December 12, 2018 File: 111473003

Reference: Proposed Changes to the Layout of Infrastructure for the Alamos Gold Inc. Lynn Lake Gold Project (Canadian Environmental Assessment Reference No. 80140)

Maps 5, 7, and 11 in Appendix B of the PD show the preliminary general arrangement of Project infrastructure at the MacLellan site as originally proposed. These three original PD maps are reproduced in **Attachment A** of this letter for ease of reference. **Attachment B** contains amended versions of these same Maps 5, 7, and 11 now showing the currently proposed (revised) layout of Project infrastructure at the MacLellan site. **Map A** overlays key features of the original and revised MacLellan site layouts for comparison purposes.

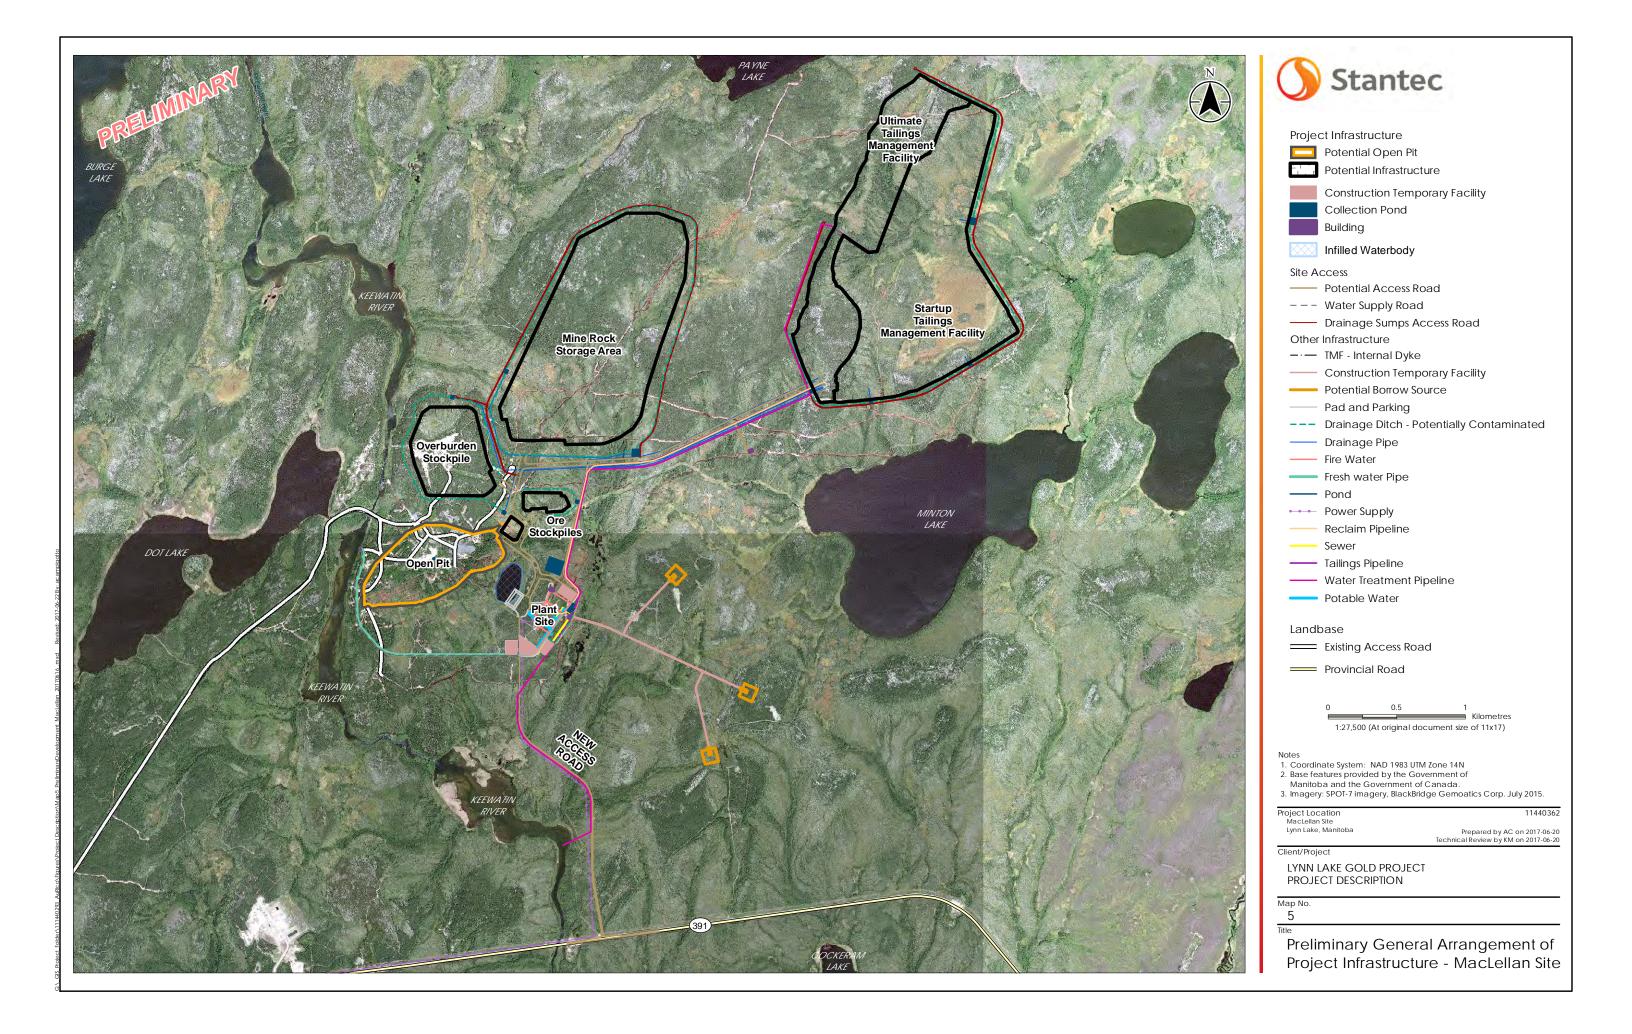
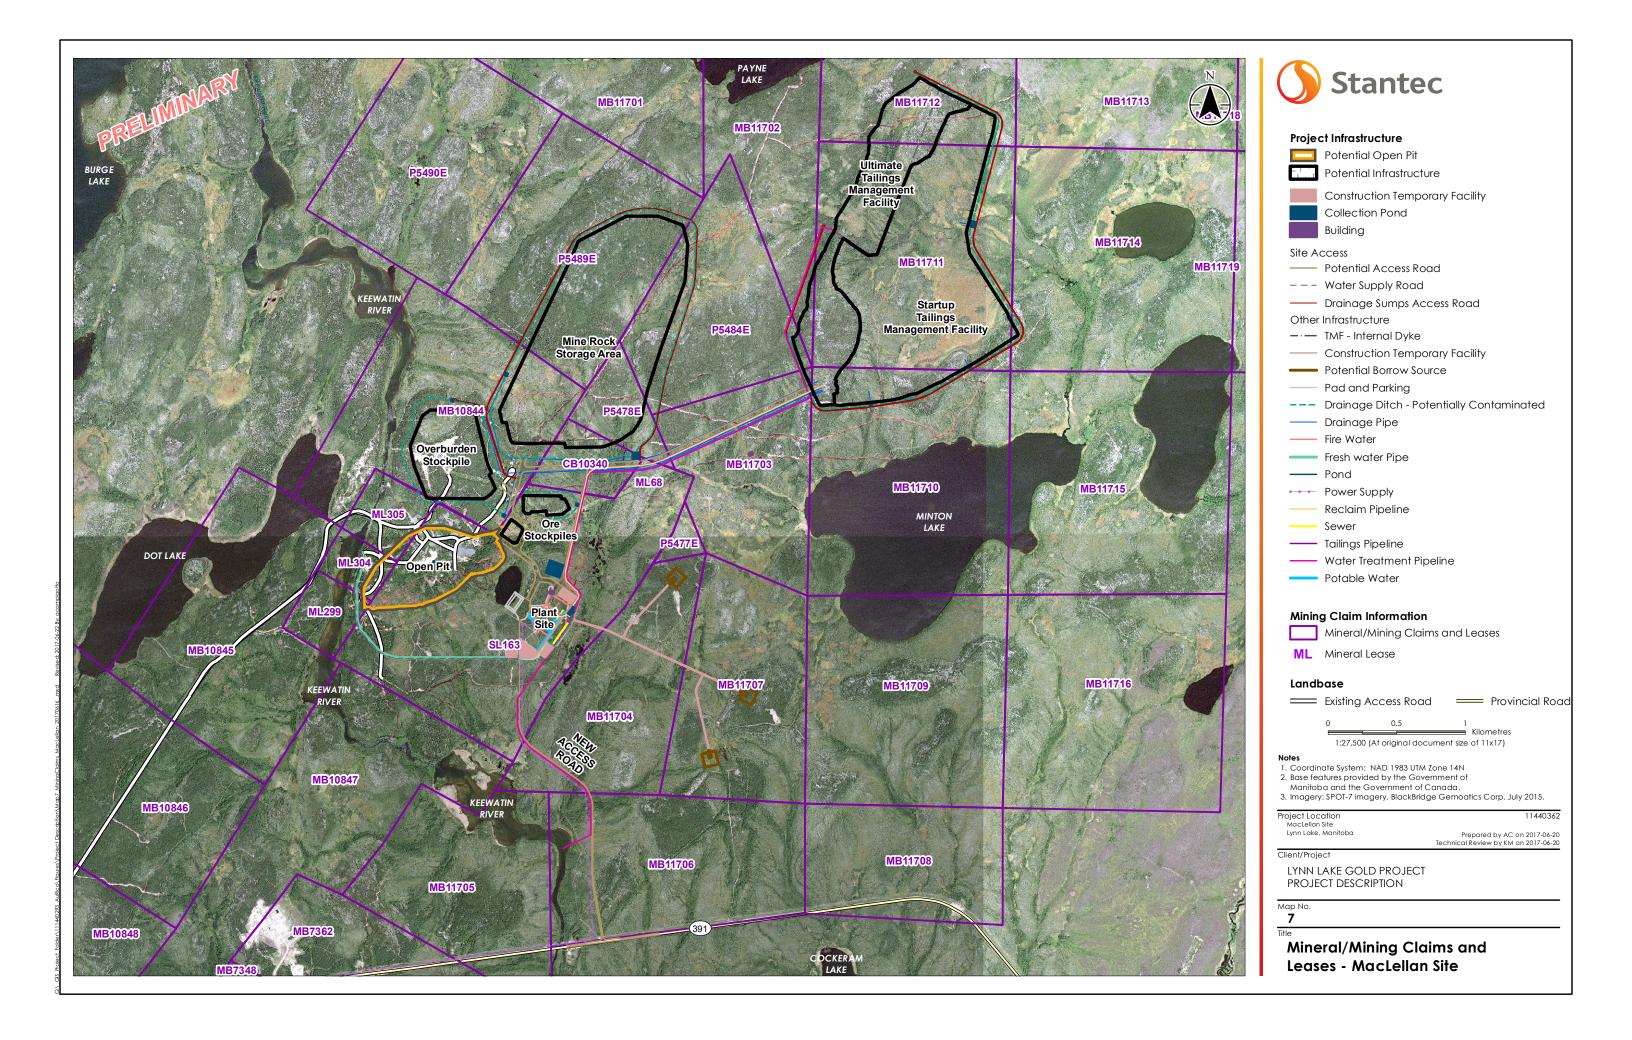
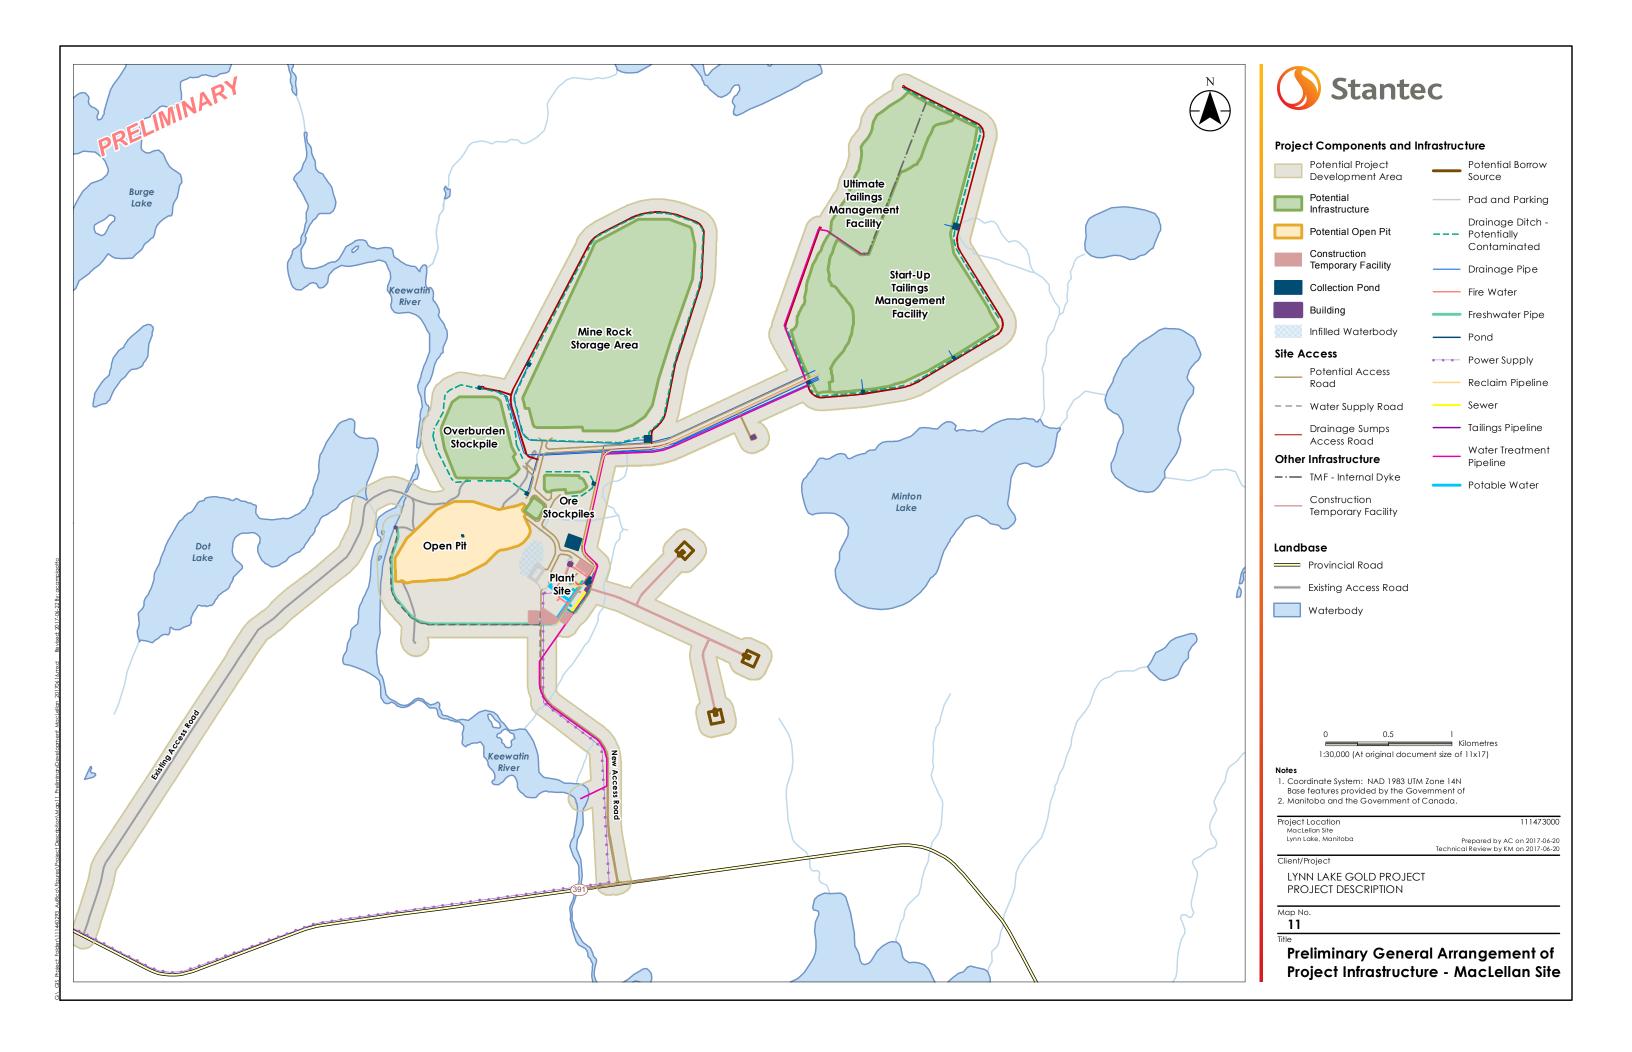
As illustrated on **Map A**, approximately 50.8% of the revised PDA occurs within the same footprint as the original PDA. The total area occupied by the revised PDA (approximately 1,105 hectares [ha]) is approximately 1% smaller than the total area occupied by the original PDA (approximately 1,120 ha). The layout of the revised PDA is also more compact than the original PDA. Consequently, this smaller area and compacted layout of the revised PDA overlaps fewer undisturbed lands as well as fewer mineral/mining claims and leases than the original PDA (refer to Maps 5 and 7 in **Attachments A and B**).

Proposed Change(s) to the Project	Rationale for Proposed Change(s)	EA Implications
The TMF will be relocated approximately 1.5 km to the west and the total surface area occupied by the revised TMF will increase from approximately 241 ha to approximately 254 ha.	 Moving the TMF to a more central location will contribute to increased compaction of the total PDA footprint at the MacLellan site, which is expected to improve flow and enhance operational efficiency by reducing on-site travel distances and associated travel time. The total surface area to be occupied by the TMF has increased as a result of the natural topography in the revised TMF location and efforts to reduce the dam volume while still maintaining the required capacity. 	 The shorter travel distances between the more central revised TMF location and other Project facilities at the MacLellan site will reduce potential greenhouse gas (GHG), dust, and other air emissions associated with transportation within the MacLellan site PDA. Minton Lake has very little assimilative capacity. Moving the TMF further away from Minton Lake and its headwaters may decrease potential mass loading from the TMF to that lake. Due to the closer proximity of the tailings to Payne Lake, the revised TMF location may cause additional loading to the provided TMF location.

Construction of a new 2.6-km southern access road is no longer proposed; the existing 4.6-km western access road will be used instead. The power supply will follow the existing western access road rather than the originally proposed southern access road.	The revised plant site (described in the corresponding row of this table above) will be easily accessible via the existing western access road. This will remove the requirement to construct a new southern access road, thereby eliminating substantial costs and scheduling constraints associated with winter construction in wetland areas.	 Removal of the requirement for a new southern access road will reduce the overall size of the PDA and associated Project-related physical disturbance and potential environmental effects (including to wetlands) during construction and operation. Removal of the southern access road will result in approximately 7 km of additional travel (in each direction) for Project-related trucks transiting between the Gordon and MacLellan sites, which will increase potential GHG, dust, and other air emissions from Project-related transportation outside of the MacLellan site PDA. Upgrades to the existing western access road are not anticipated to be required. As indicated in the original PD, it is anticipated that Manitoba Hydro will independently undertake the necessary upgrade to the existing power supply from Laurie River to Lynn Lake and provide the power distribution to the MacLellan site from Lynn Lake. Alamos will not have the ability to direct or influence the construction of the power distribution system (including pole line and substation). The upgraded power distribution system is expected to be assessed, built, owned, and operated by Manitoba Hydro. The power distribution system will also be entirely under the care and control of Manitoba Hydro and is therefore excluded from the scope of the Project to be assessed. The western access road is located entirely within the boundaries of the original PDA.
